"
**Water Right Conditions
Tracking Slip**

PUBLIC INTEREST REVIEW FOR GROUND WATER APPLICATIONS

TO: Water Rights Section Date 07/02/2014
 FROM: Ground Water/Hydrology Section Michael Thoma / Josh Hackett
 SUBJECT: Application G- 17773 Reviewer's Name Supersedes review of
 Date of Review(s)

A. GENERAL INFORMATION: Applicant's Name: Attila Koppany County: Umatilla

Figure 2: Application area map. (G-16859 refers to the original permit POA for taxlot 4000, which is subdivided under this application – see application map)

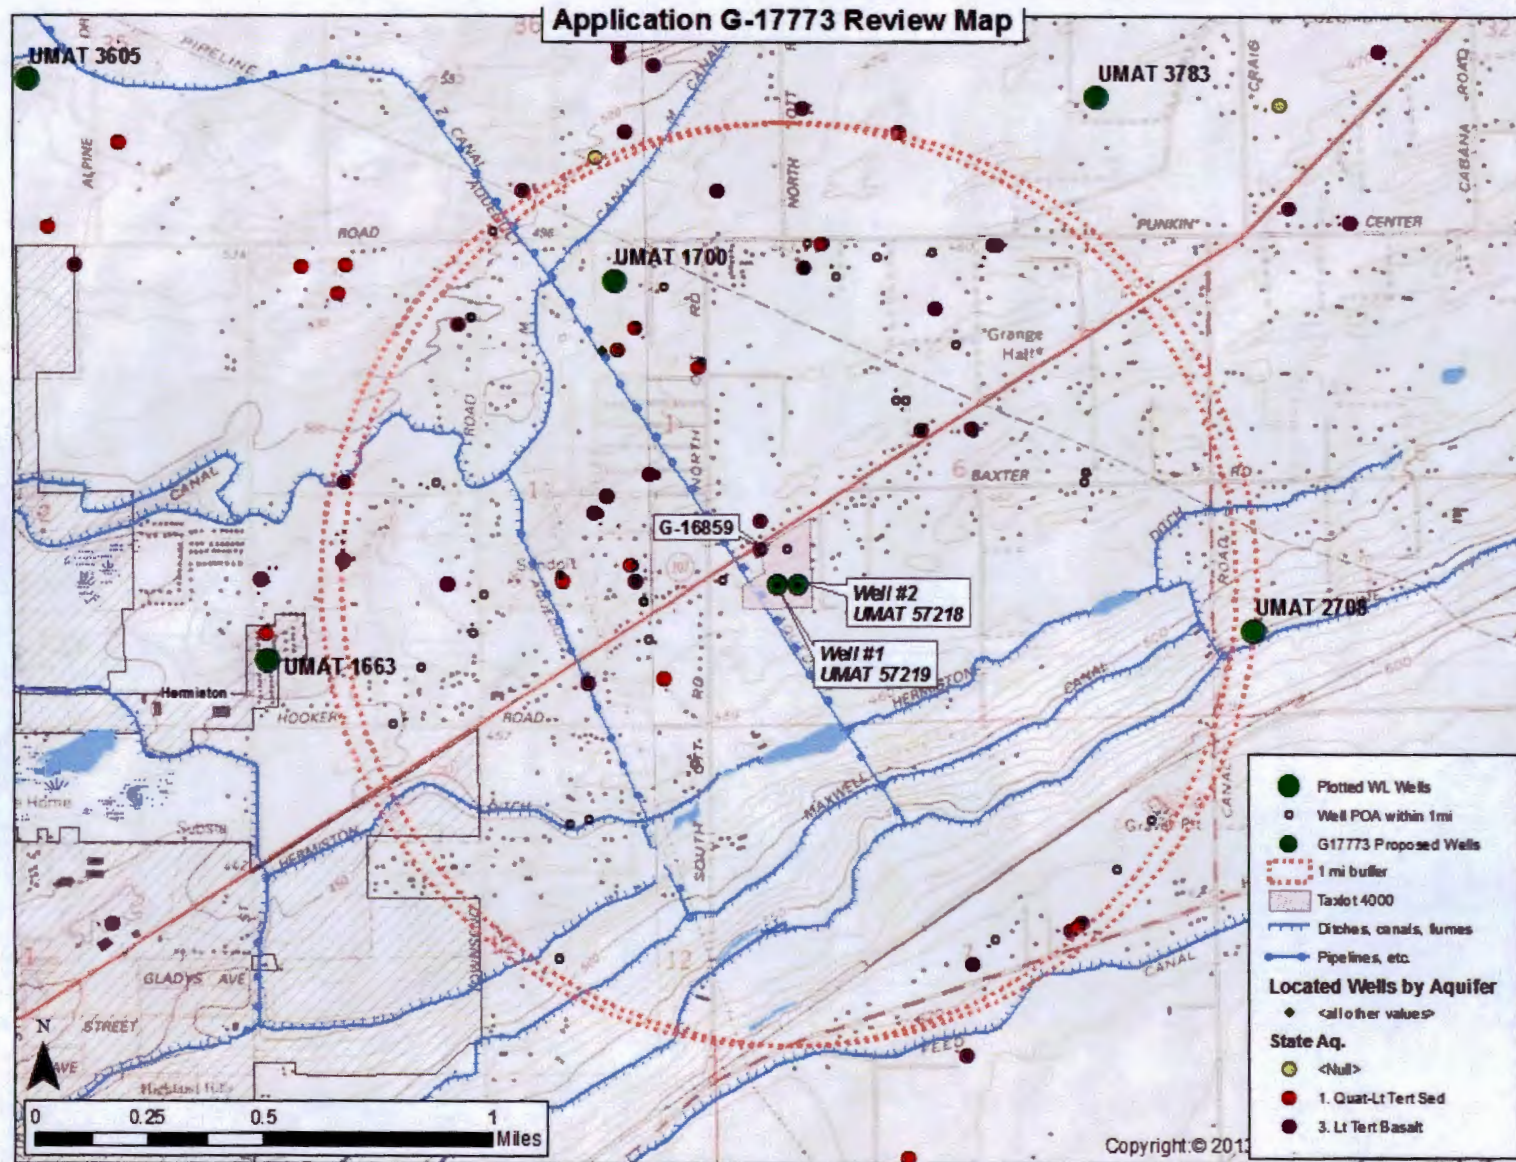
B3. **Ground water availability remarks:** There are many low-use alluvial residential and irrigation wells in the area around the property (see Figure 1) and many small, recent water rights with groundwater POAs, generally < 10 acre with post-2000 priority dates. Well logs in the area indicate approx. 50 – 150 ft of alluvial material overlying basalt. Alluvium wells generally yield 40 – 100 gpm (0.09 – 0.22 cfs) which is sufficient for these small-parcel water rights. Regarding water level history, there is only 1 alluvial well that is reporting water levels (UMAT 3605) but this well, and many of the shallow basalt wells in the area (with completed depths < 250' bls), show no signs of water level declines over the past 30 years (see Figure 2). Therefore it is likely that the proposed rate and use of this application will not greatly impair the alluvial system.
